## ALPINE CITY PLANNING COMMISSION MEETING

**SUBJECT: Preliminary Plan Review - Bertha's Place Subdivision**

Subject: **Bertha's Place Plat A – Preliminary/Final Review**  
**4 lots on 1.42 acres**

Subject: **The Ridge at Alpine – ENGINEER’S PRELIMINARY REVIEW**  
**72 Lots on 189.5 Acres, CR 40,000 Zone**

**THE RIDGE AT ALPINE**  
PARKING CONCEPT FOR PARK  
ALPINE, UTAH

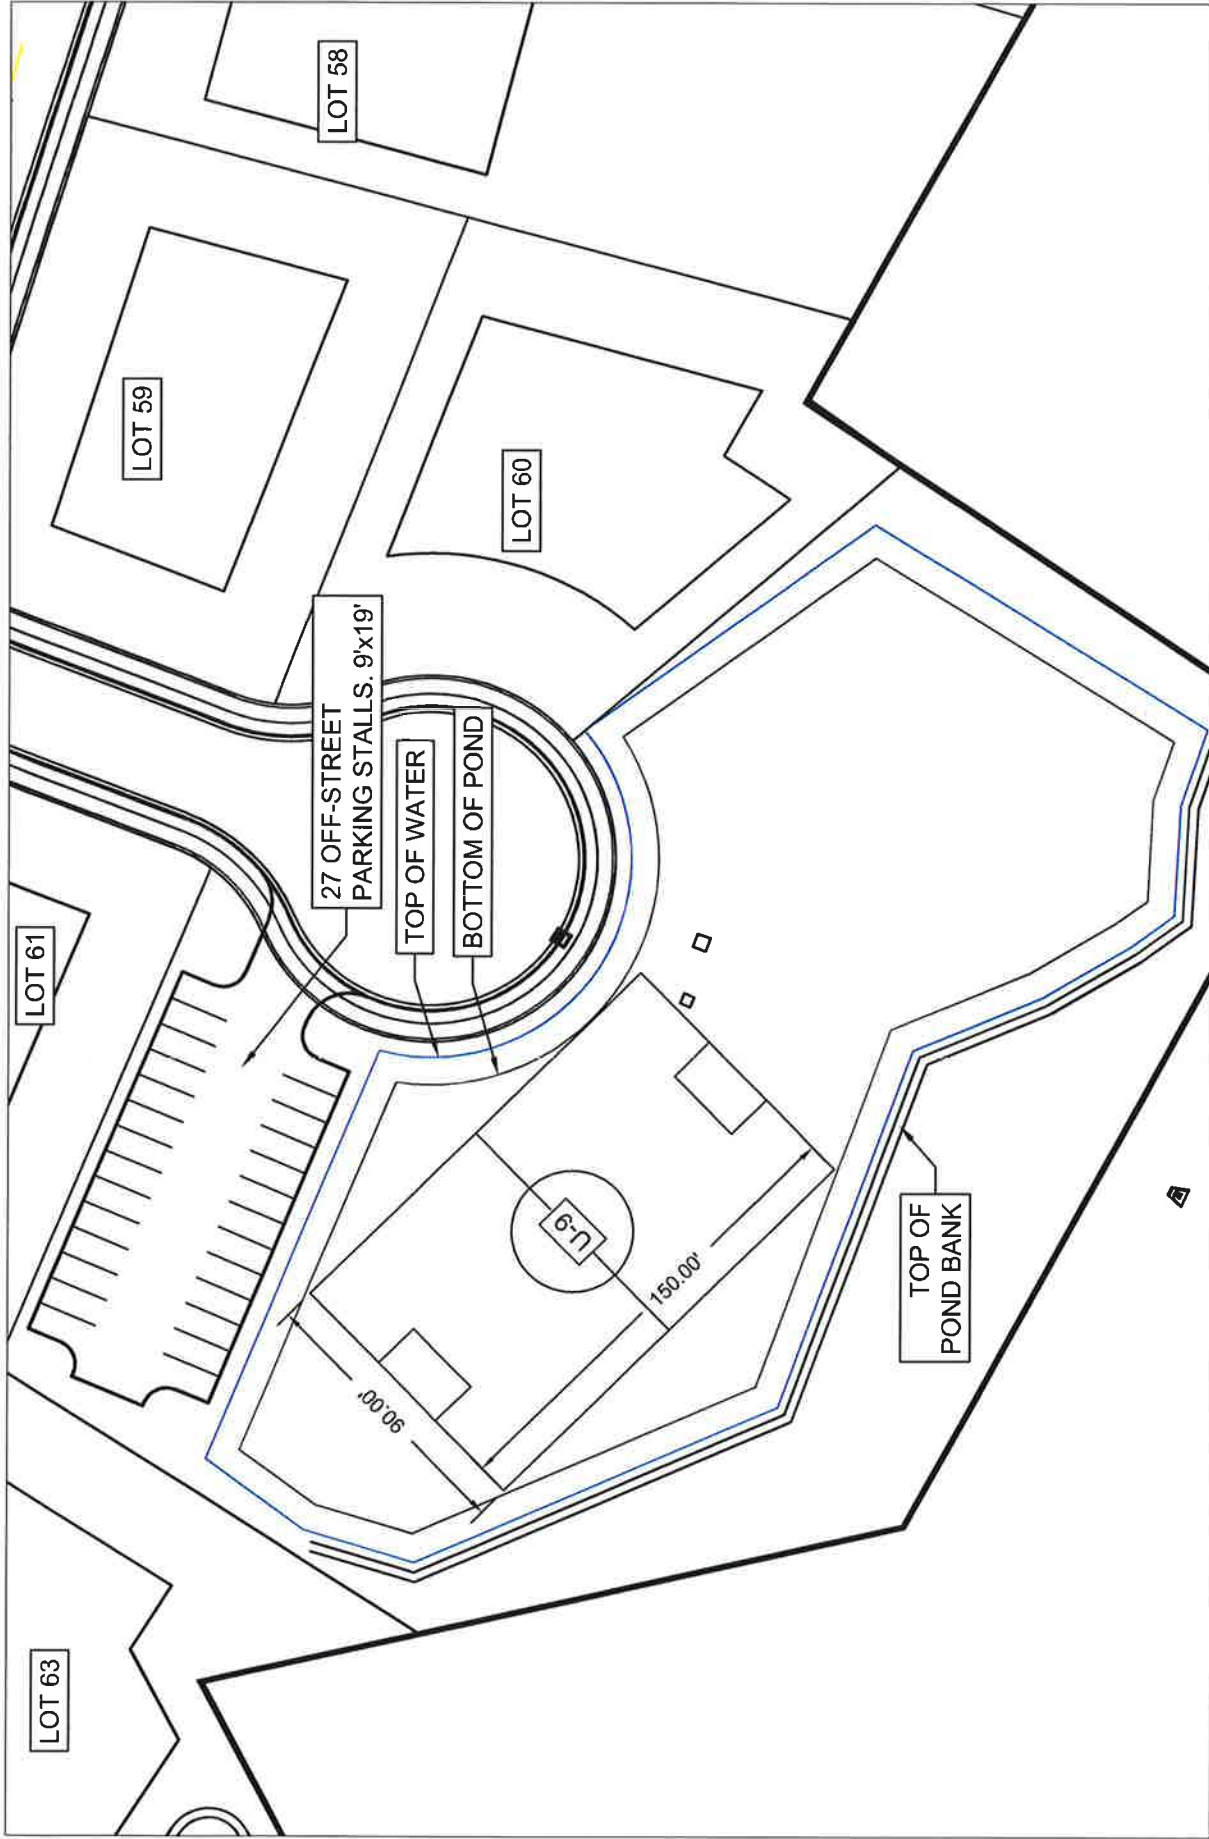
At concept, it was discussed that the developer needed to add parking for both the proposed trailhead and soccer field. Parking has since been added and the proposed preliminary plans currently show 5 off-street parking stalls for the trailhead and 27 off-street parking stalls for the soccer field.

Per the US Soccer Foundation, it is recommended that there be a minimum of 45 parking spaces per field (see official Soccer Field Handbook). As for trailhead parking, the Trail Committee has reviewed the proposal and does not feel that 5 stalls would be sufficient for the estimated use of the proposed trailhead and recommends 15 off-street parking stalls.

Based on the standards set forth by the US Soccer Foundation and the observations of the Trail Committee, it is recommended that additional parking be added to meet the anticipated use for both the trailhead and soccer field.

- The Developer eliminate or modify “Lot 72” to meet the scenic intent and dwelling cluster requirements of a PRD.
- The Developer correct the discrepancy in the plans regarding “lot 67”.
- The Developer address parking concerns for the trailhead and soccer field.
- The Developer implement the proposed alignment as recommended by the Trail Committee.

# THE RIDGE AT ALPINE TRAILHEAD EXHIBIT ALPINE, UTAH

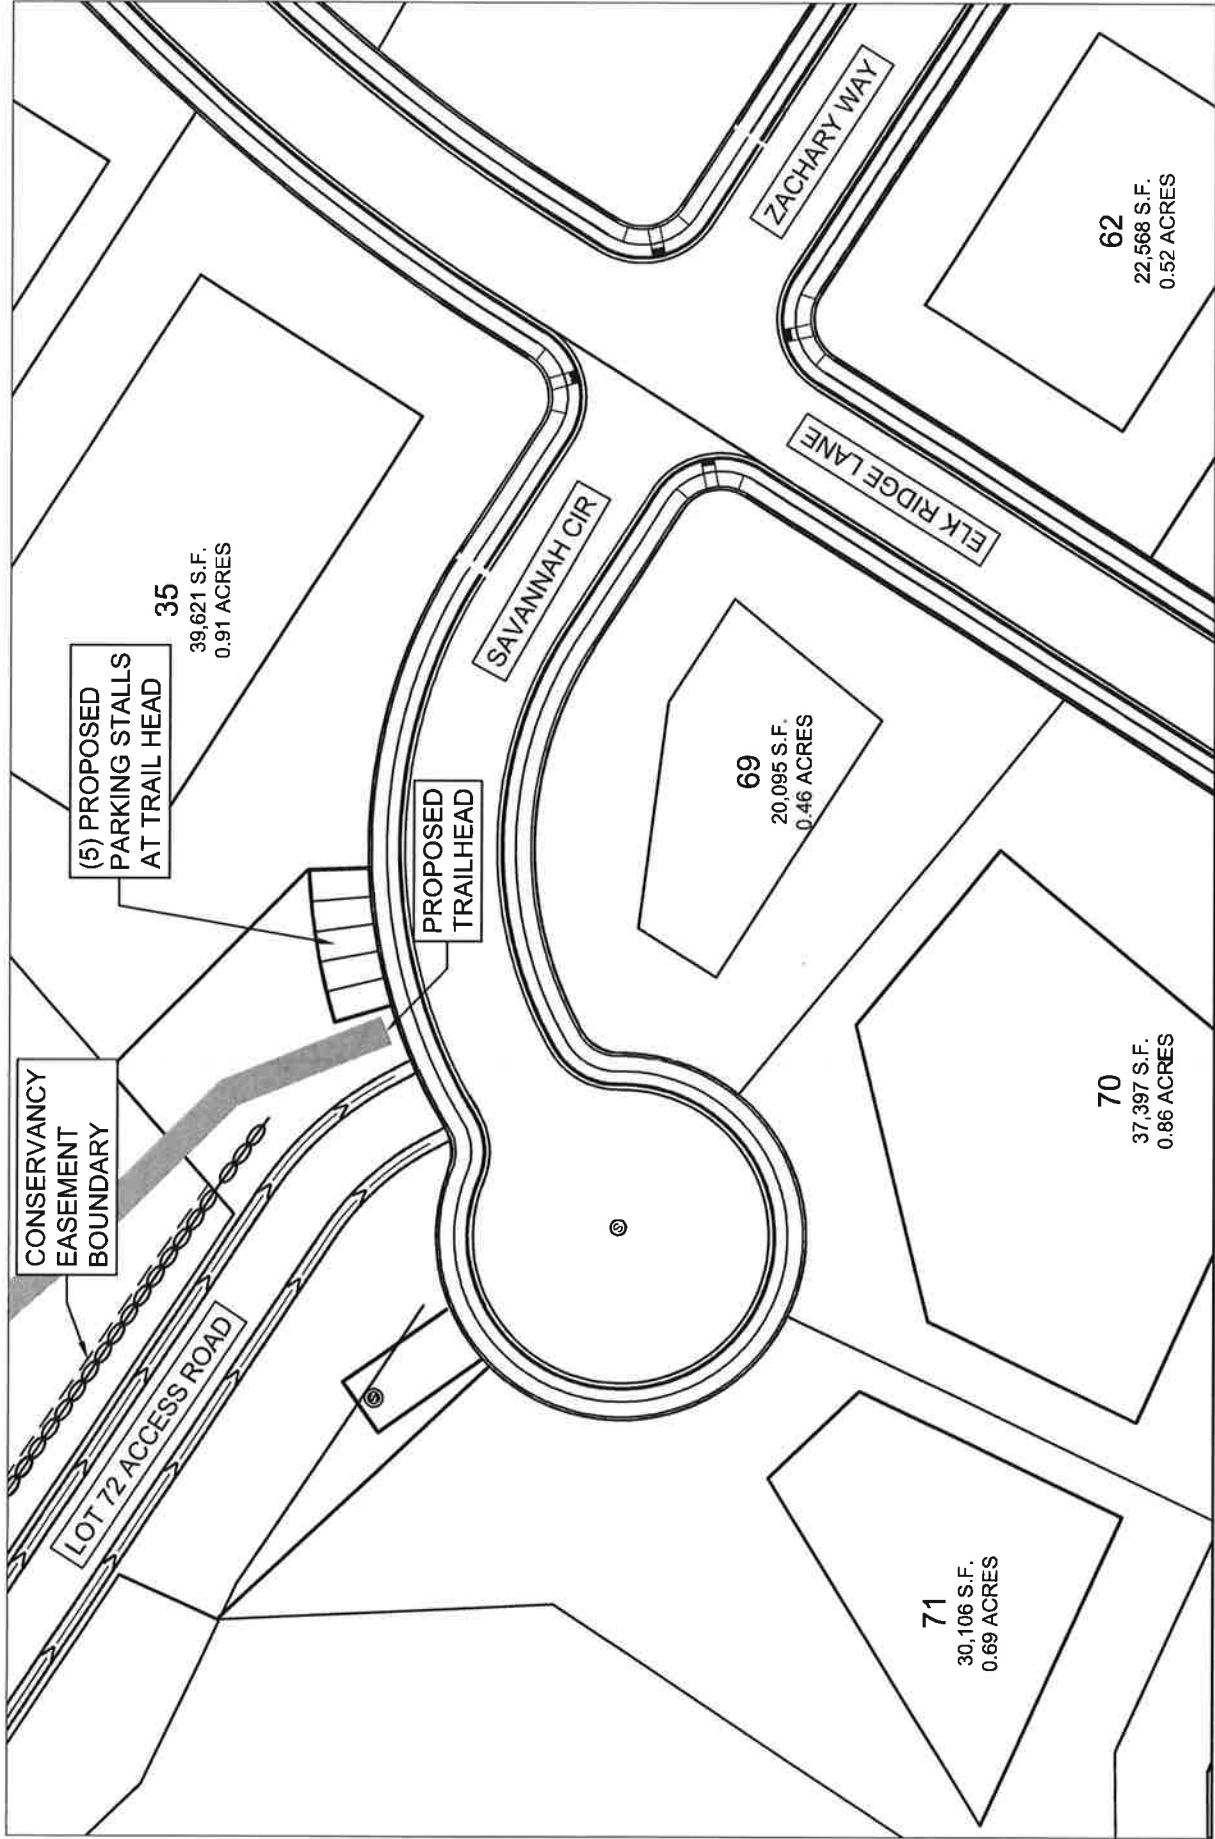
The proposed subdivision will include public trails. The **plans currently show two trails** located on the westerly side of the property. The alignment of trails has been discussed in relation to the slope and terrain of the area. The intention is that there will be one trail that will connect the trail at the northwest corner of the Heritage Hills open space and a future trail in the Three Falls Ranch open space.

The second trail is proposed to connect the cul-de-sac at the frontage of the proposed “lot 72” to the Three Falls Ranch open space. Plans show trailhead parking with 5 off-street parking stalls.

The trail committee has recommended alternate alignments for both proposed trails (see attached pictures), one (fulfilling the requirement for the conservation easement) on the far west side of the property linking Heritage Hills to Three Falls. The second trail, providing access from The Ridge
